REVIEW OF WATERFORD III BASEMAT ANALYSIS

Structural Analysis Division
Department of Nuclear Energy
Brookhaven National Laboratory
Upton, NY 11973

June 21, 1984

Figure 3.13 Strength developments of concretes made with rapid-hardening cements. (Adapted from W. Perenchio, in *New Materials in Concrete Construction*, ed. S. P. Shah, University of Illinois at Chicago Circle, Chicago, 1972, p. 12-VI.)

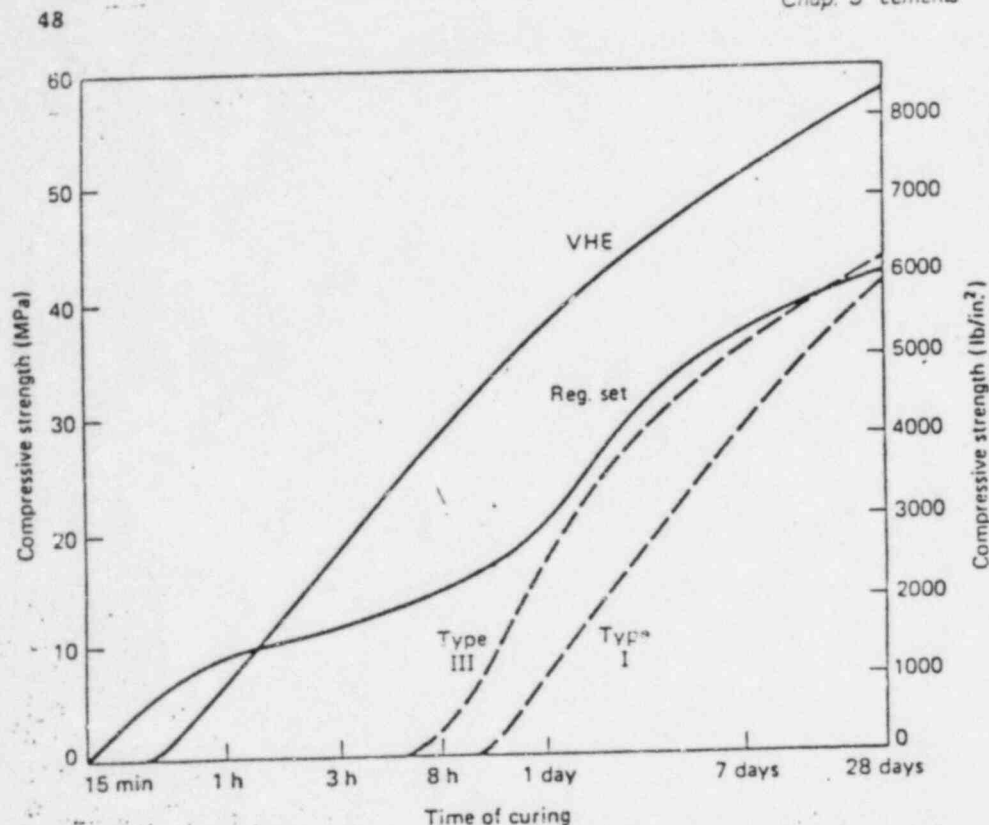
fill the void volume created by soil settlement. The concrete block would then be supported on the soil rather than "hanging" from the other block. Figure 4 shows the concrete strength gain during the first day. As may be seen concrete will have no strength until about 12 hours. By this time all of the soil settlement would have occurred and the second concrete block would not induce any loads on the first block.

Fig. 1 Estimated Side Loads On Wall

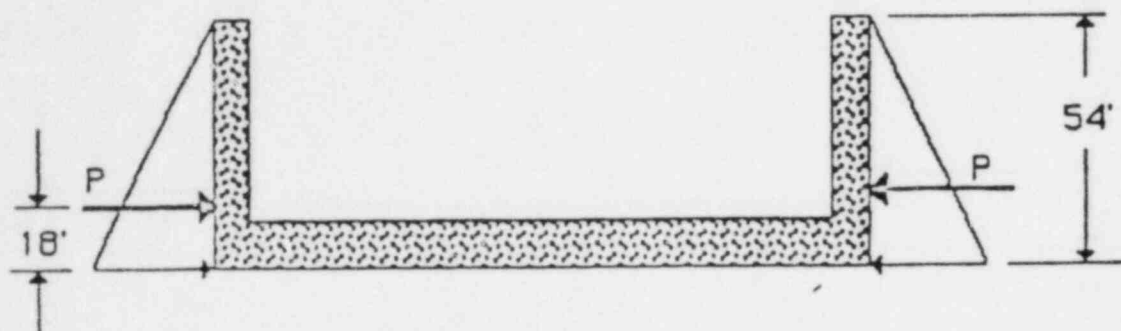
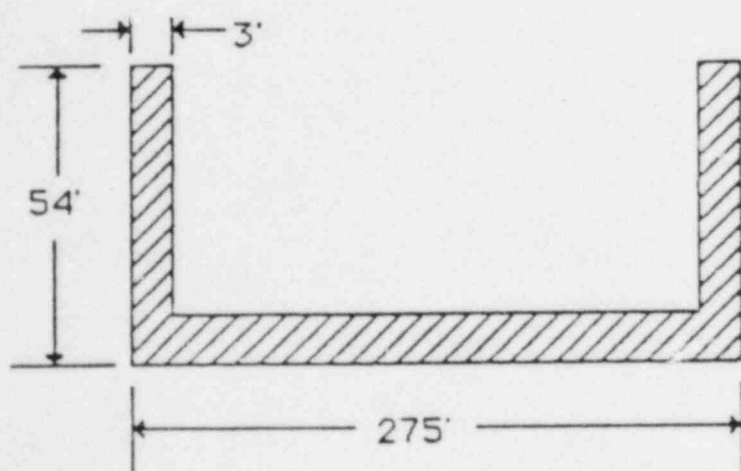
Table B.1 lists the horizontal loads which act on the sidewalls due to the various load combinations. These loads were determined directly from the HEA/Ebasco computer printouts. An elevation of the structure parallel to the long direction of the basemat is shown on Fig. B.1. The forces (P) are taken as the forces shown on Table B.1 and acting on walls #2 and #4. The soil pressure is assumed to have a triangular variation as shown so that the resultant force (P) acts at the third point on the wall. Since the wall is buried about 54', the resultant force acts at a point 18' up the wall from the bottom of the basemat.

The stresses caused by this loading in the cross section shown on Fig. B.2. The basemat is analyzed as a beam structure. The cross section shown in Fig. B.2 has the following properties:

The average stresses in the slab for these two load cases are 51 psi and 38 psi respectively. The average shear in the basemat for Case 8 loadings was found to be 50 psi. If this shear stress is combined with the 38 psi average compressive stress one finds that the tensile stress in the concrete is reduced to 34 psi. It is unlikely that this stress could cause a shear (diagonal tension) failure.
